REF: JD 16/92

ERRATA

BATTERY TRANSIT RELAY – REMOVAL

FIG 1

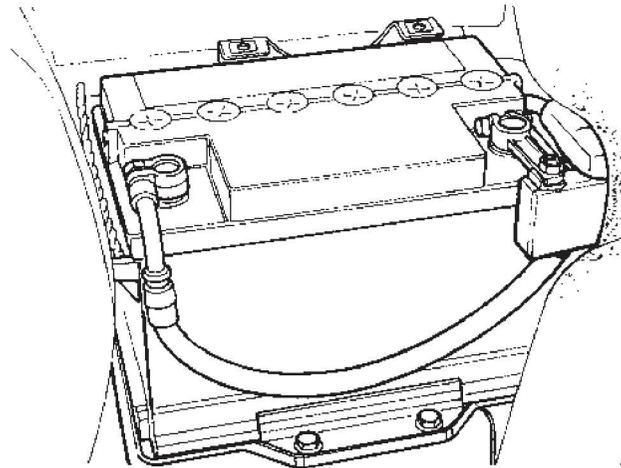
Owing to the relocation of the battery into the boot at 93 MY, a revised battery transit relay has been introduced, (see Fig 1).

The procedure for the removal of this new relay is as follows:

1. Open the boot and remove the battery cover, (see Fig 2).
2. Remove the negative lead from the battery.
3. Disconnect the transit relay from the battery.
4. Remove the white / yellow (W/Y) ignition wire from the transit relay.

FIG 3

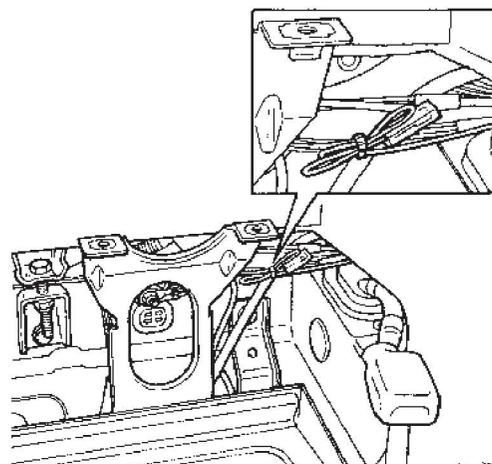
5. Remove the positive lead from the transit relay terminal post, (A, Fig 3).
6. Reverse the positive lead clamp and refit the clamp to the positive lead (B, Fig 3).

FIG 4

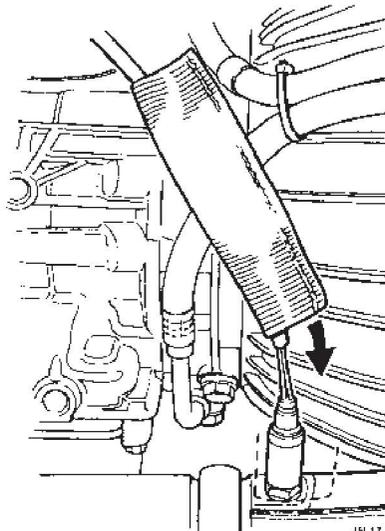
7. Displace the battery.
8. Tie back and secure the white / yellow (W/Y) ignition wire, (see Fig 4).
